AGENDA

President and Board of Trustees
Village of Arlington Heights
Board Room

November 19, 2015

SHEET NO.
A0.30

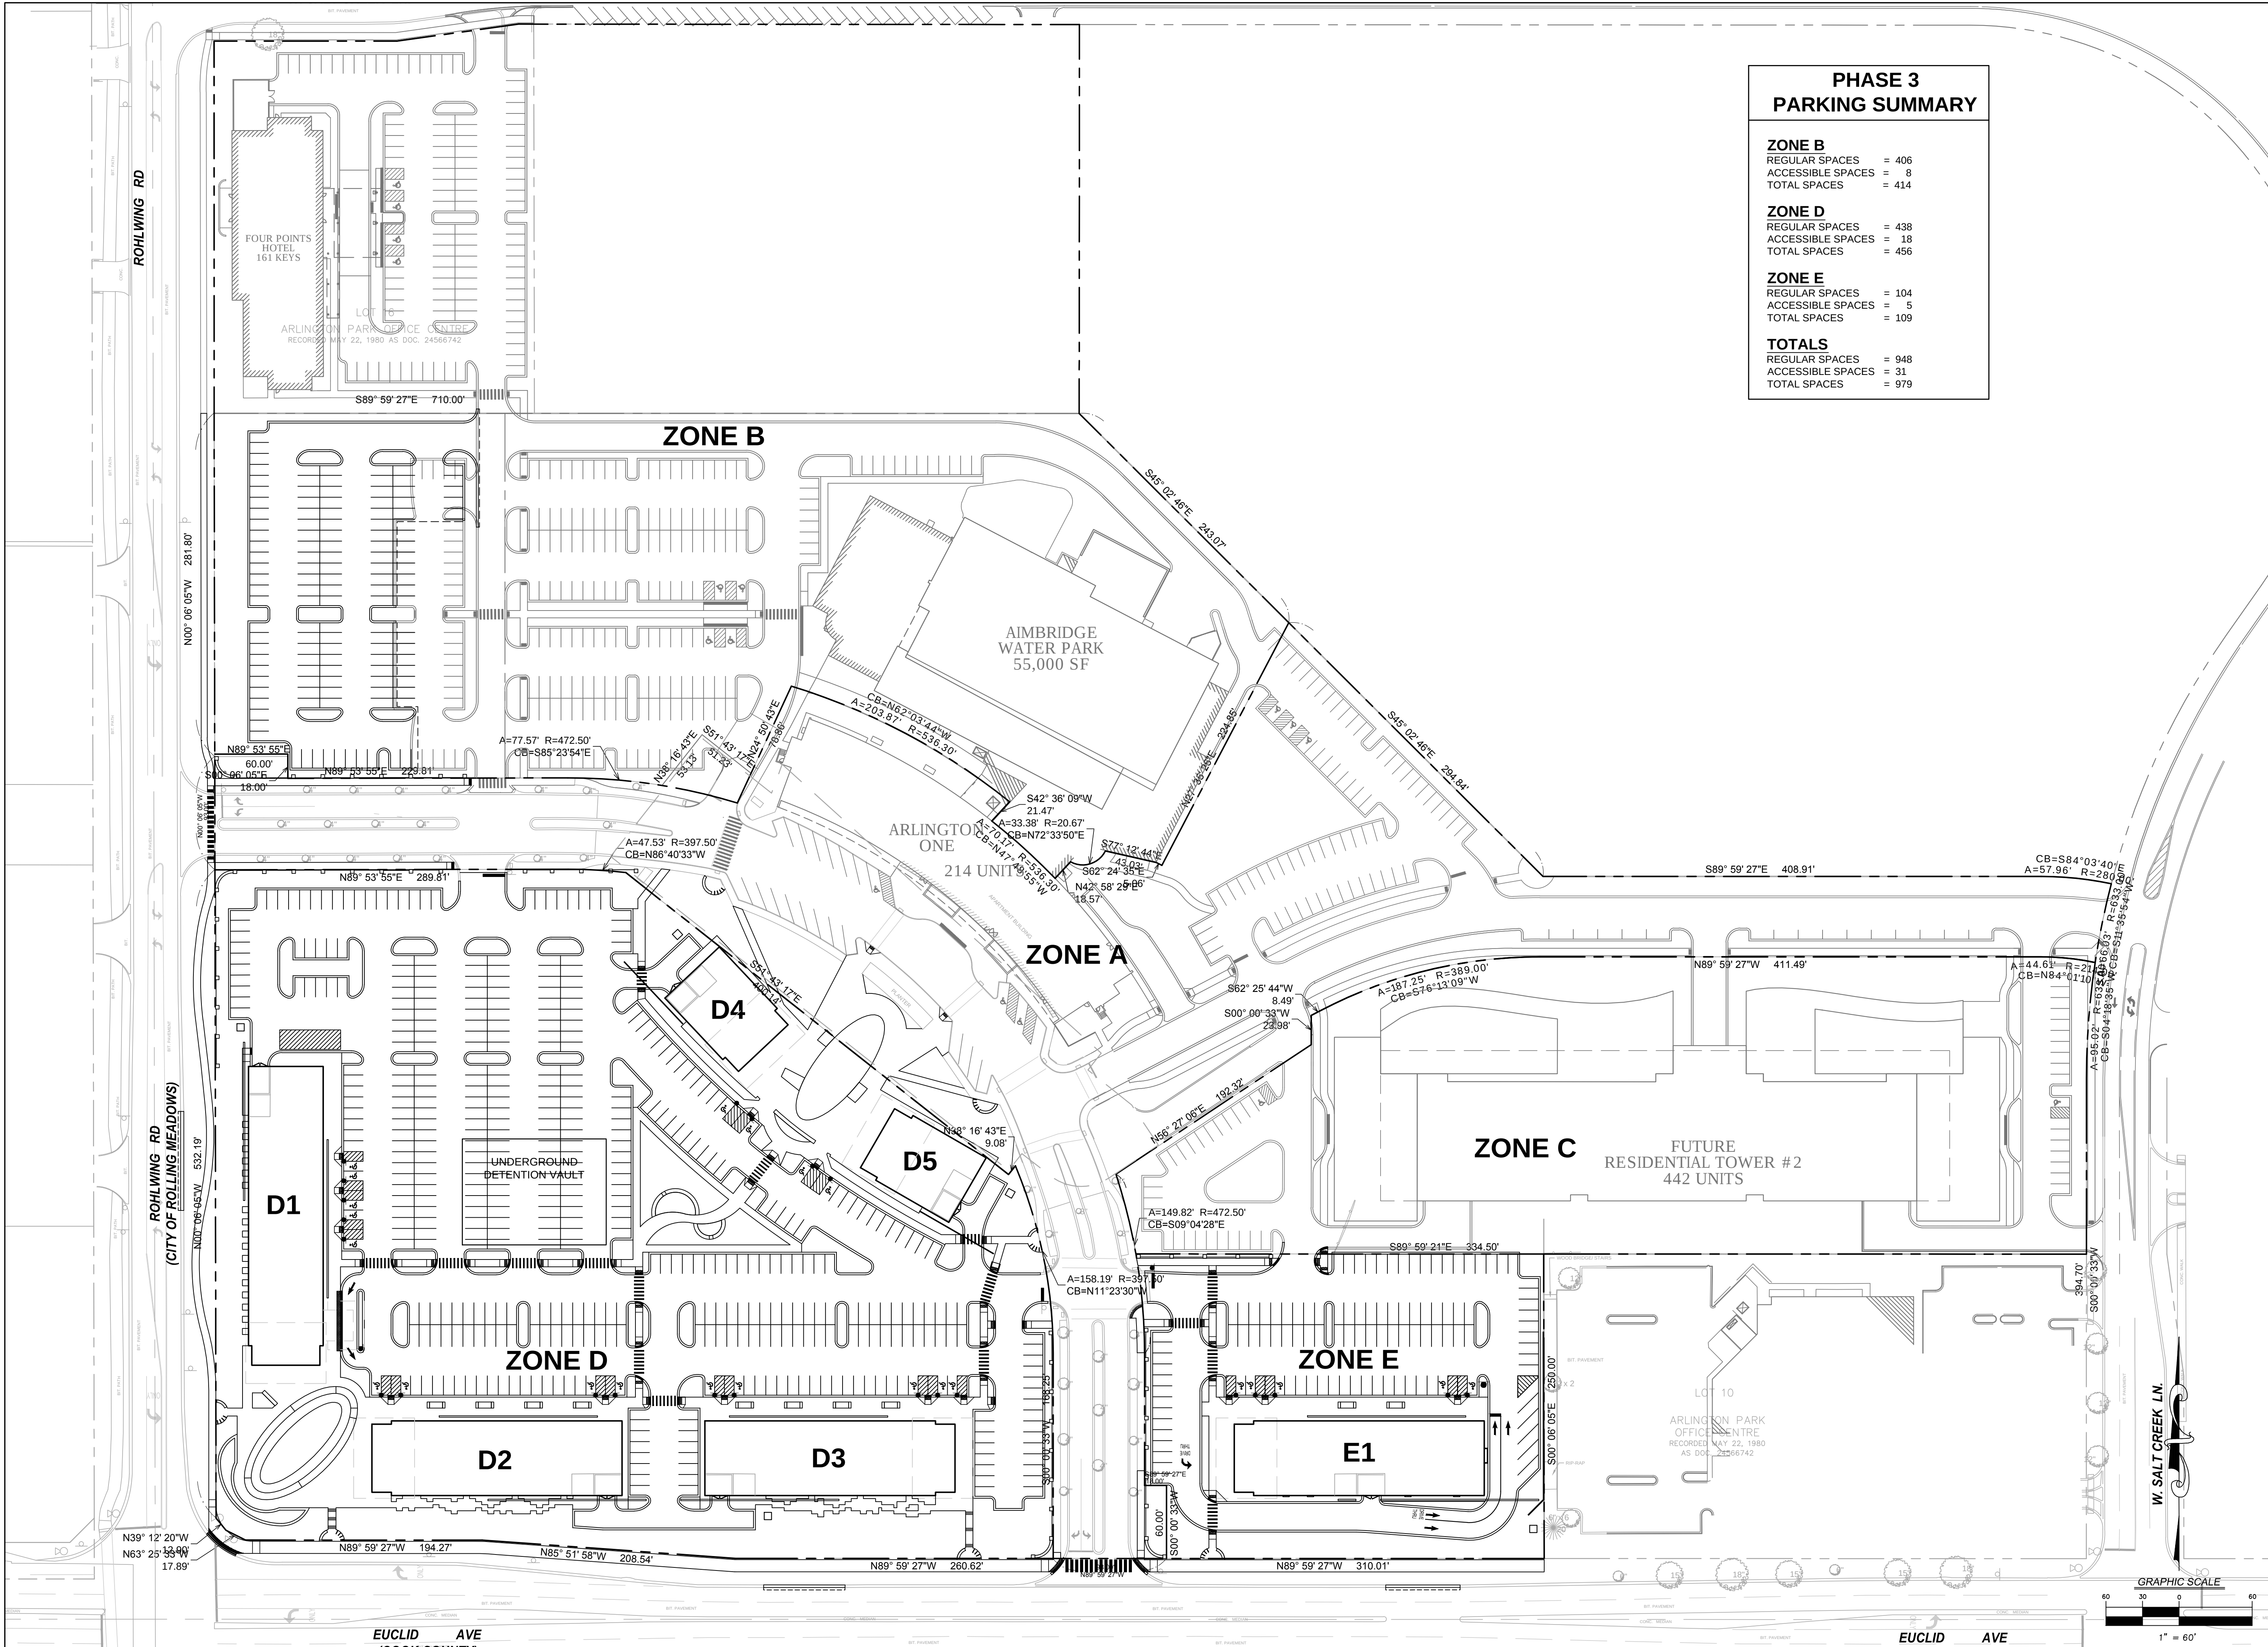
20. Properly reflect curb cuts and striping for 10 ft. bike path crossings at the Arlington Downs driveway and at Rohlwing Road.
21. Sheet A-3: The Subject Property Map shows the elimination of the regional basin in favor of five (5) football/soccer fields. This has significant implications to the ultimate stormwater management system which, if this scenario is anticipated, should be resolved now.

Sheet A-3: The Subject Property Map shows the elimination of the regional basin in favor of five (5) football/soccer fields. This has significant implications to the ultimate storm water management system which, if this scenario is anticipated, should be resolved now.

C4.1

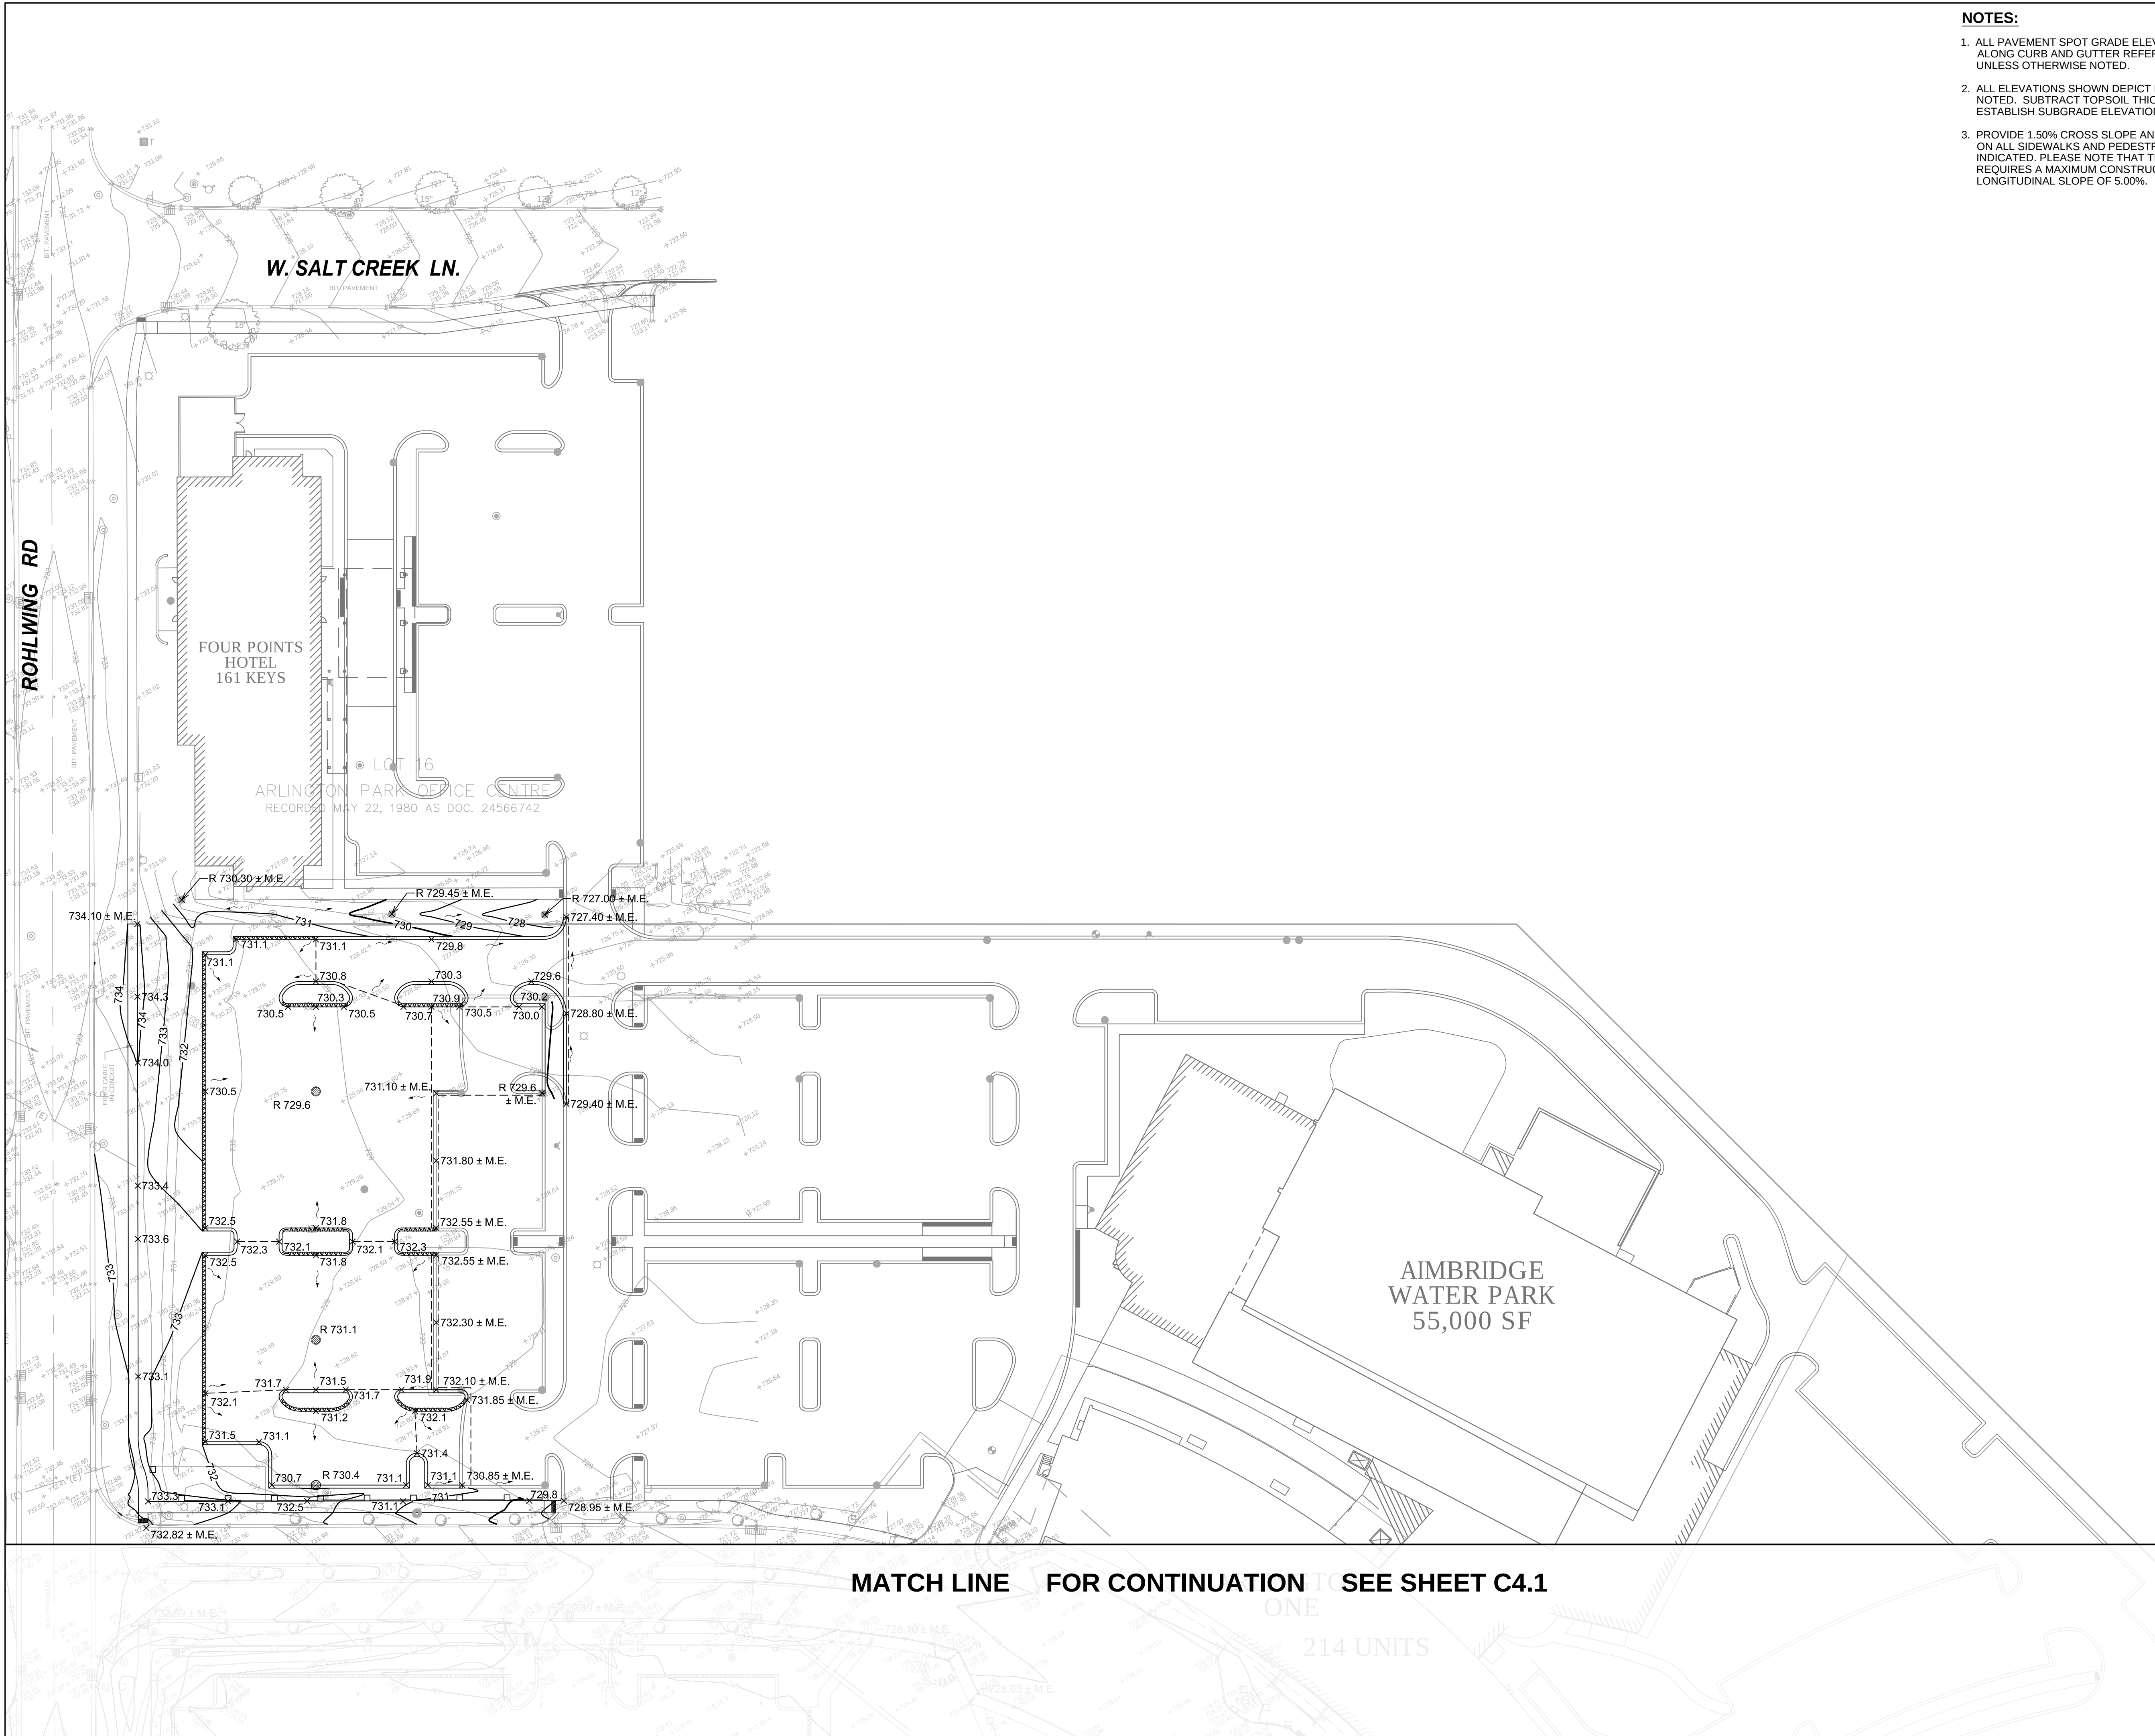
(Planning review comment 3 pertains to sheet C4.1 of the application document)

SHEET NO.
C5.1

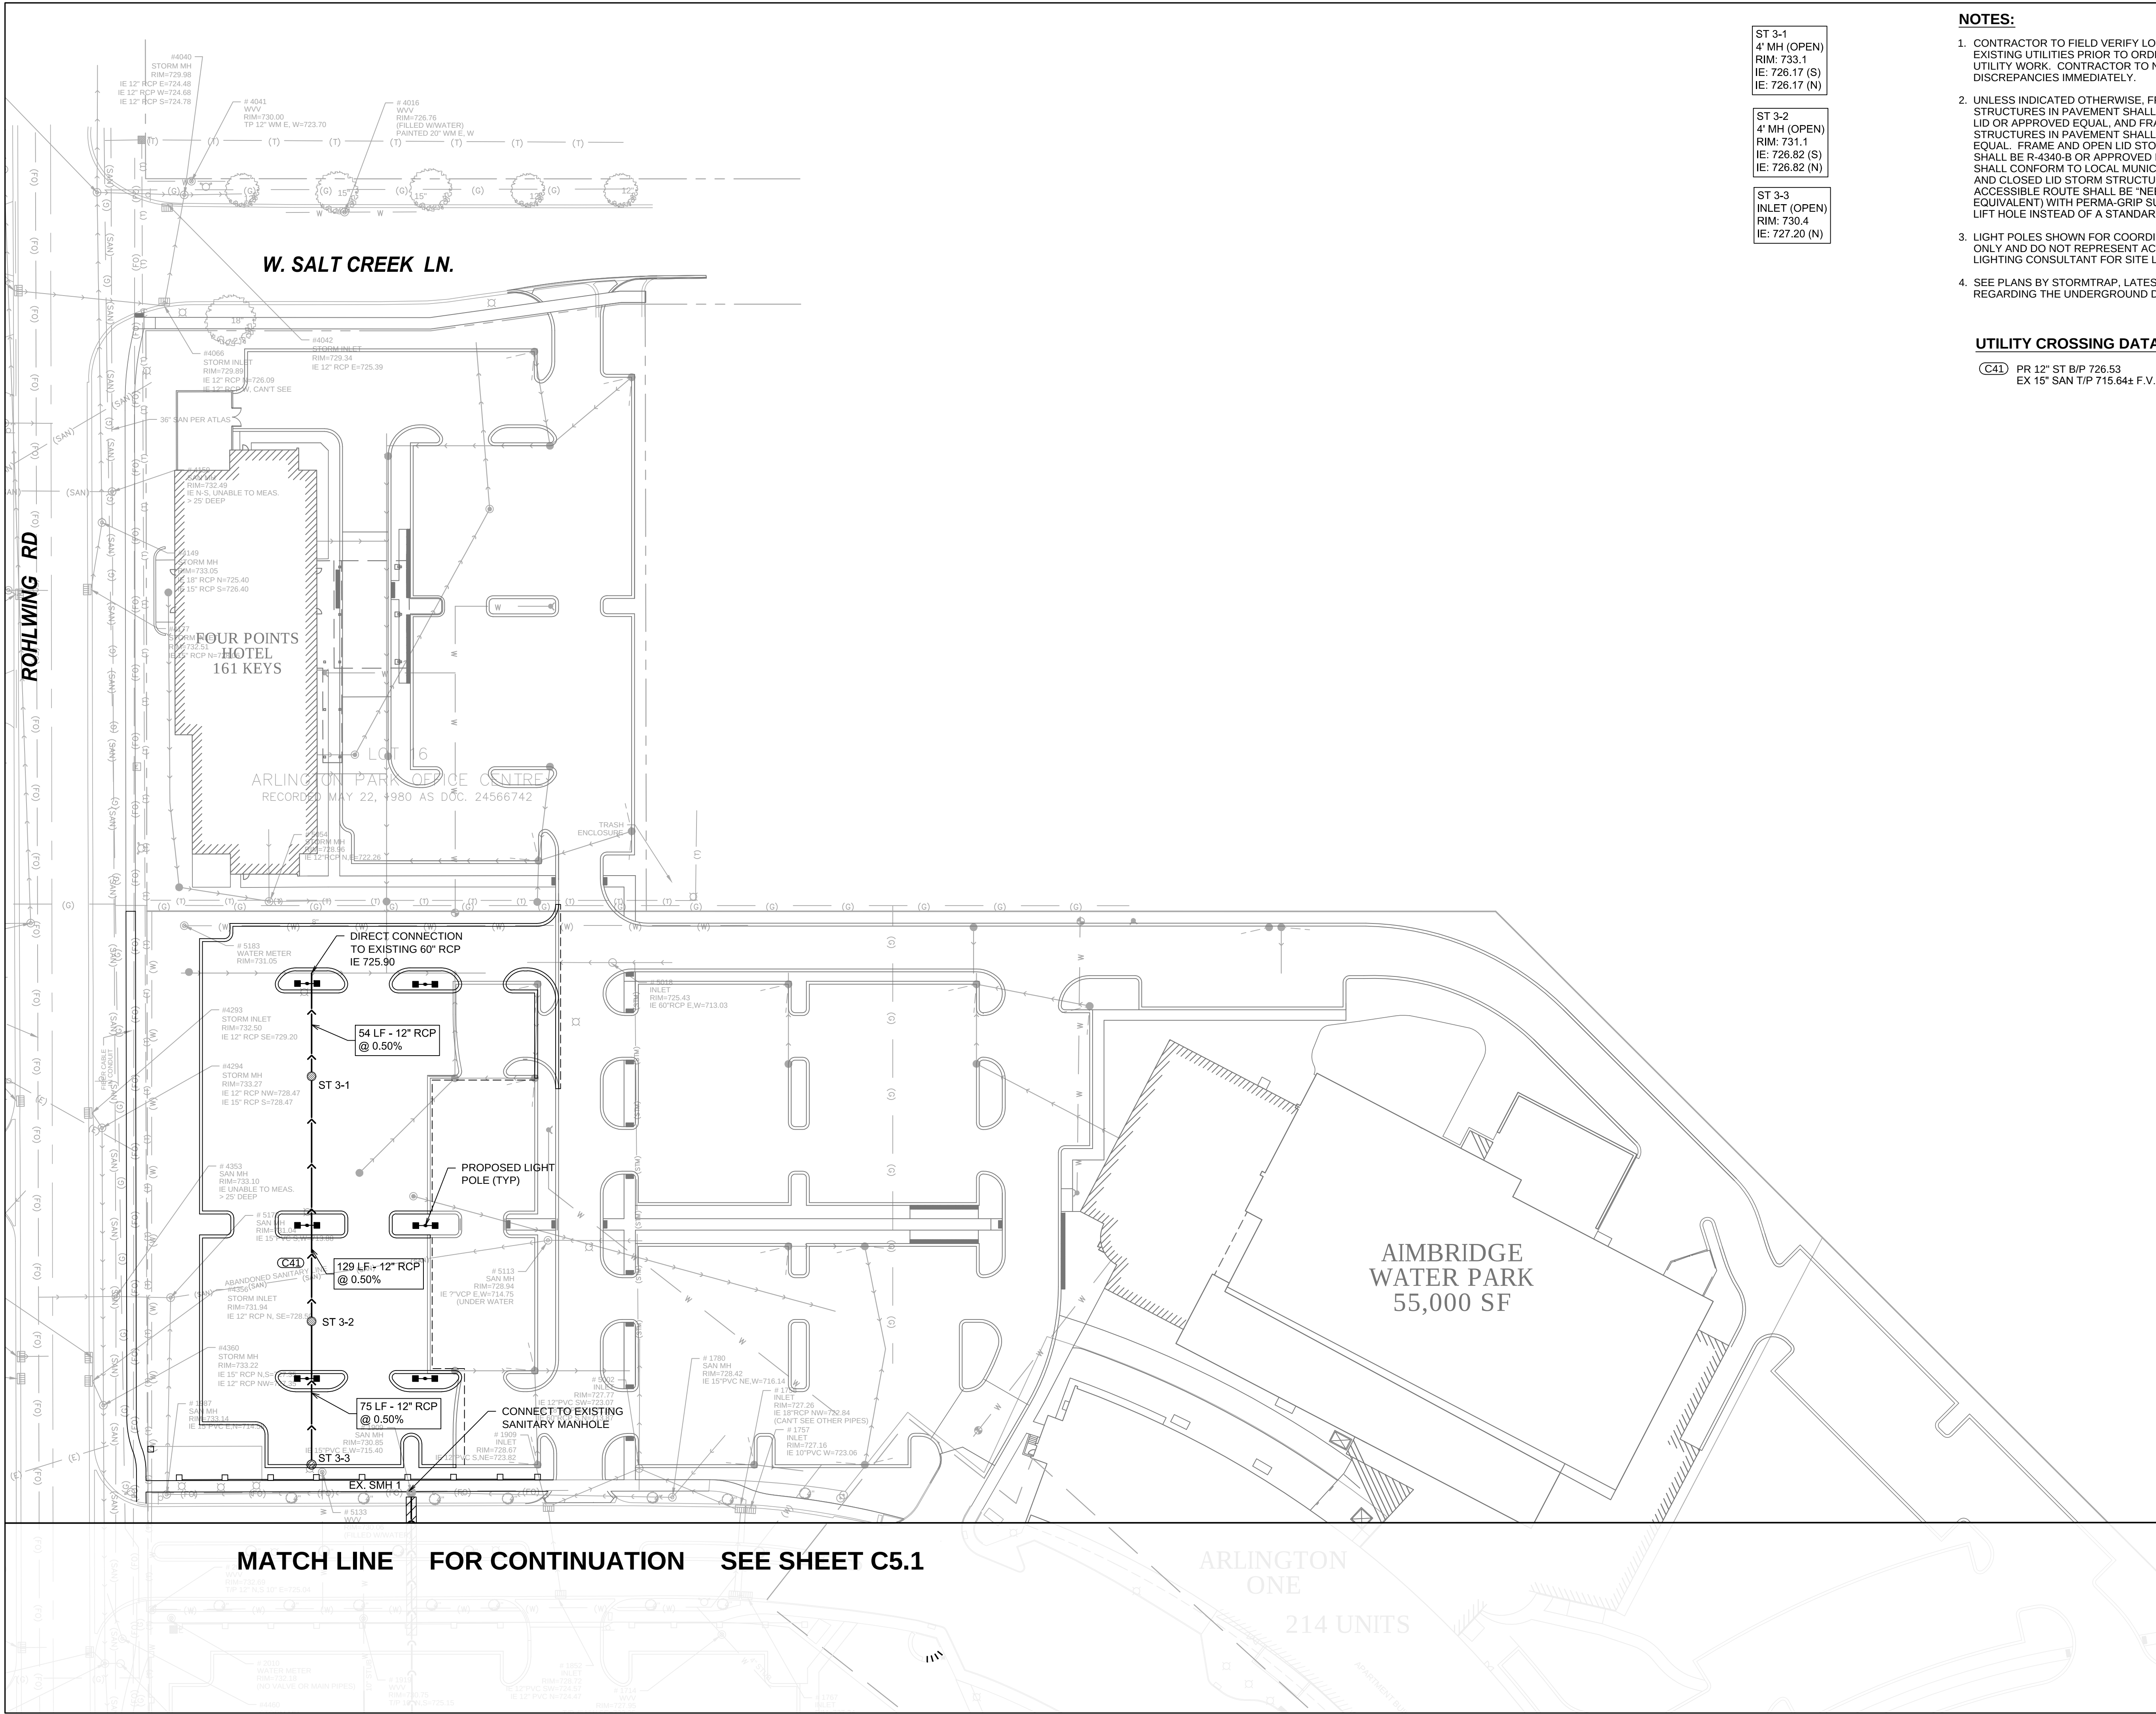
24. Sheet C-5.1: Stormwater runoff (downspouts) from the buildings along Euclid Avenue must be conveyed to the site detention system and not allowed to freely flow onto the Euclid Avenue ROW. Clearly show this on the site plan.

Sheet C-5.1: Storm water runoff (downspouts) from the buildings along Euclid Avenue must be conveyed to the site detention system and not allowed to freely flow onto the Euclid Avenue ROW. Clearly show this on the site plan.

Storm drain connections have been added to sheet C5.1 for all of the proposed buildings. All building storm drainage will be routed to the onsite storm water detention facility.
